Informal document GRSP-52-28
(52nd GRSP, 11 - 14 May 2012,
agenda item 14)

Regulation No. 29 – 03 series of amendments

Proposal for amending GRSP/2012/19

Front pillar impact test (Test B)

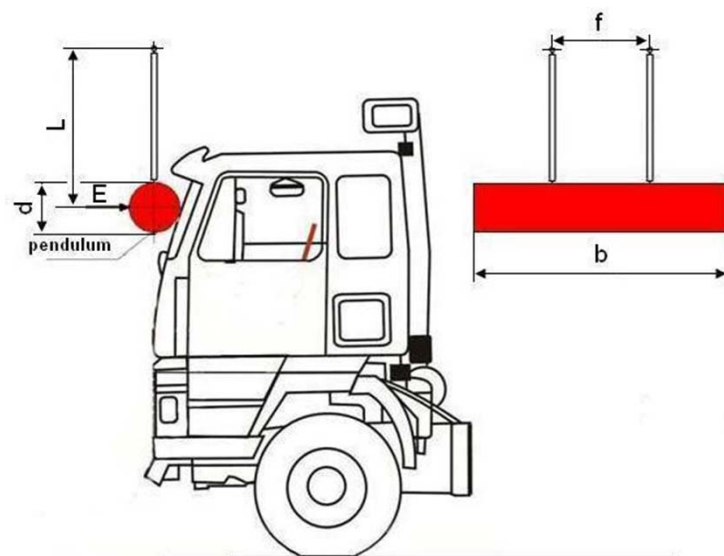
Vehicles of category N_2
with a gross vehicle mass
exceeding 7.5 t and of
category N_3

Roof strength test (Test C)

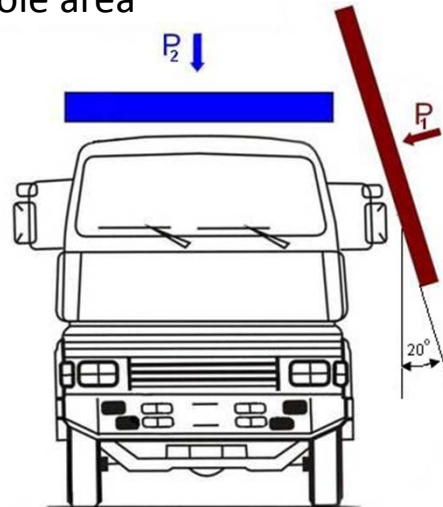
The loading device face shall cover the whole area of the cab roof.
